CHANGES FROM BASE PRODUCT UDS-10BC (3716) TO UDS-10BC(COG) (6535):

UDS-10BC(COG)

Part No
6535

BE-004551-00-21

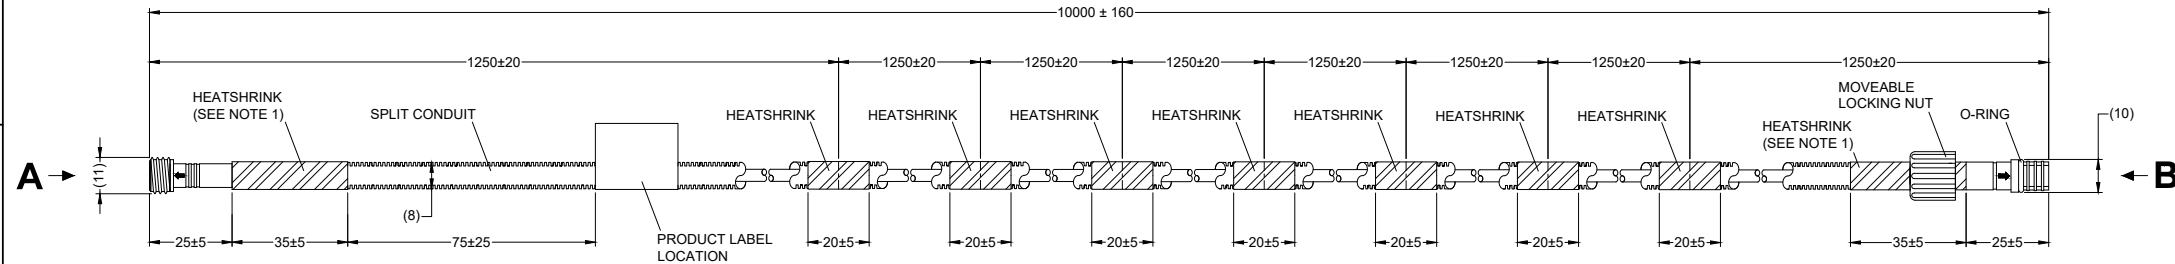
1. SPLIT CONDUIT ADDED TO LENGTH OF CABLE.
2. HEATSHRINK ADDED AT EACH END TO SECURE CONDUIT TO CONNECTOR.
3. HEATSHRINK ADDED AT INTERVALS ALONG LENGTH OF CONDUIT.
4. CABLE LABEL CHANGED FROM UDS-10BC (3716) TO UDS-10BC(COG) (6535).
